Norwell Solar Farm Steering Group

**Application by Elements Green Trent Limited for an Order Granting
Development Consent for the Great North
Road Solar and Biodiversity Park (GNR Project)– project ref. EN010162
Unique Number [REDACTED] (Our ref NSG/1)**

Deadline 1 Lifecycle Greenhouse Gas Evaluation

Figure 2.1: Generation-Based Marginal Emissions Factors (kgCO₂e/kWh)

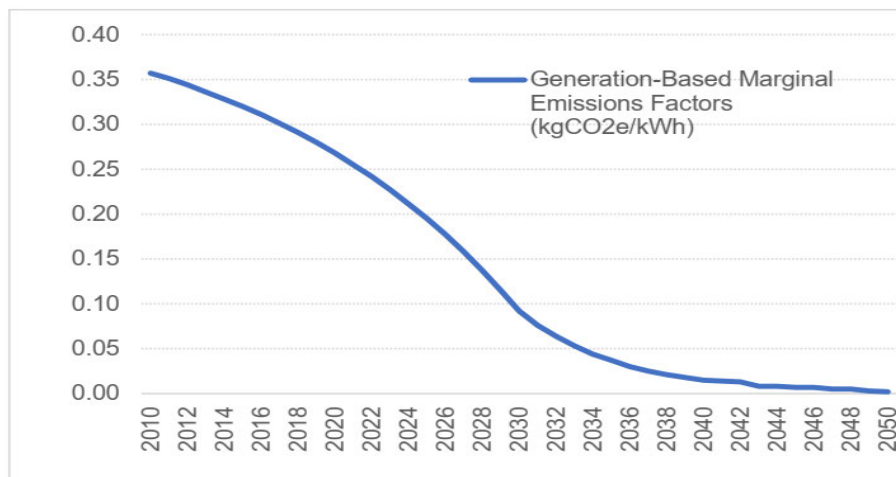
- 7.13 It appears the above findings were adopted by the Applicant as the emissions factors in Table A15.1.19 in the Appendix. In 2026 (even though it seems unlikely this project will be generating that year at all), an average emissions factor of 0.174kgCO₂e/kWh is adopted, whereas the Applicant's gas peaker evening peak factor for that year is 0.365kgCO₂e/kWh (110% higher). The Group does not challenge the use of that higher figure. Only that it should not apply for every year thereafter.
- 7.14 Employing the DESNZ modelling as above but maintaining a constant 110% uplift in emissions year on year would provide a fairer forecast of the BESS emission savings. **Appendix C shows that using this modelling would predict an emissions saving of 297,606tCO₂e.**
- 7.15 It is now possible to consolidate all the above data for emission savings for the three scenarios.

Figure 4

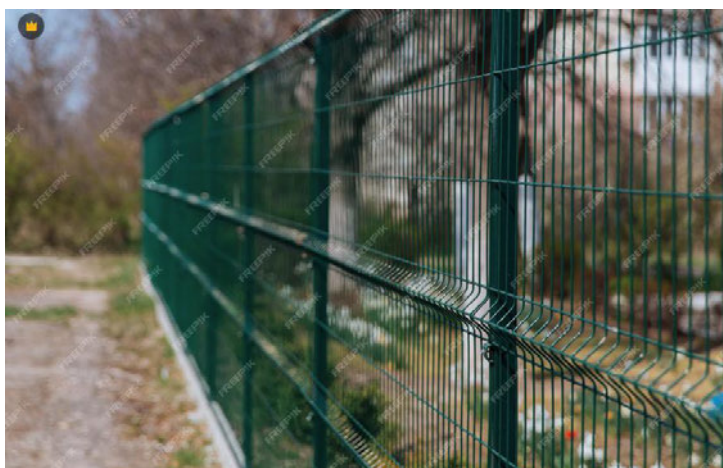
- 8.10.1 The Applicant has based their paint calculation on the inadequate fence, suitable for the BESS in design but not size.. Their 3mx1.8m fence covers an area of 5.4m². But being a mesh design, a lot of the surface area is air as can be seen in Figure 4 below. Coating all sides, the Applicant has estimated that 1.07m² will need coating. That is 31% of the total bay area.
